Technical Service Bulletin

SCBS WARNING LIGHT WITH DTC U045A:68 AND/OR PARKING
SENSOR INDICATOR FLASHING WITH DTC B1B36, B1B38,
B1B40 AND/OR B1B42

Bulletin No.: 15-002/22

2017-**2023** CX-5 with front parking (ultrasonic) sensor

Sample picture shows C-11 connector with water entry and terminal corrosion.

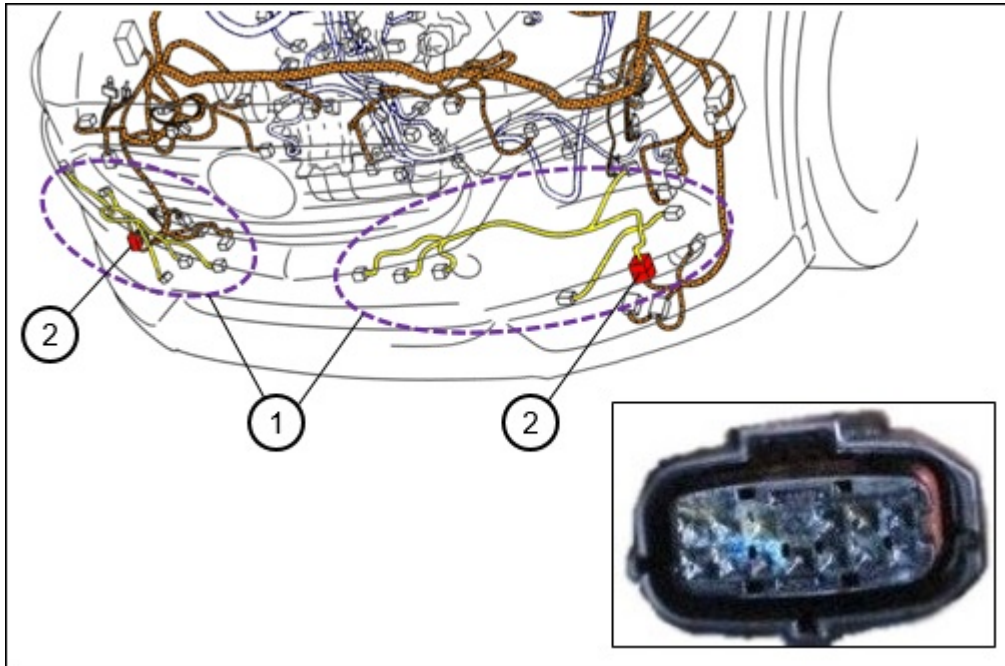
Due to insufficient waterproof performance of the front harness short cords (1), water may enter in and accumulate in the C-11 (LH) or C-12 (RH) connectors (2) causing a short circuit between wires and an improper signal being sent from the parking (ultrasonic) sensor to the parking sensor unit.

To eliminate this concern, the production process of the front harness short cord has been improved to increase waterproof performance.

NOTE: The left side is shown as a sample.

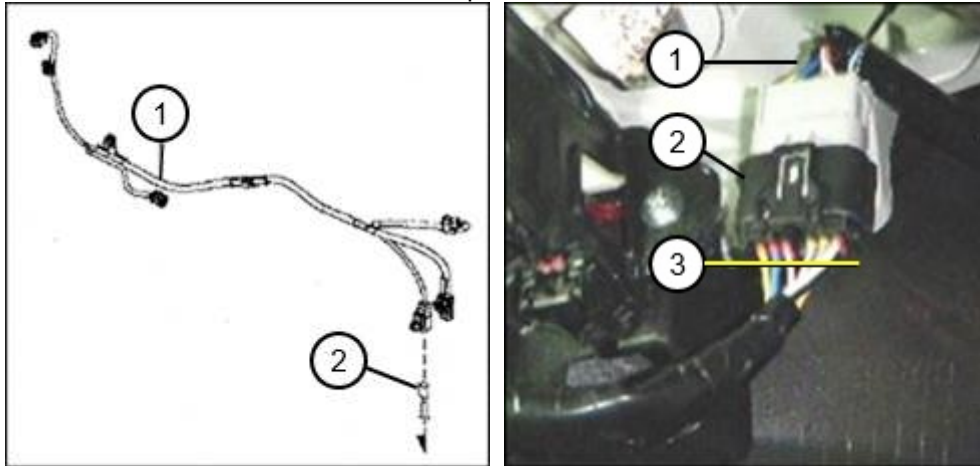
5. Blow air to remove any water away from the vehicle harness side C-11 or C-12 connector (2) terminals.
6. Check the terminals of the vehicle harness side C-11 or C-12 connector (2) for corrosion.

- If there is no corrosion, go to next step.
 - If there is corrosion, cut the wiring harness (3) and replace the connector (2) with a new one.
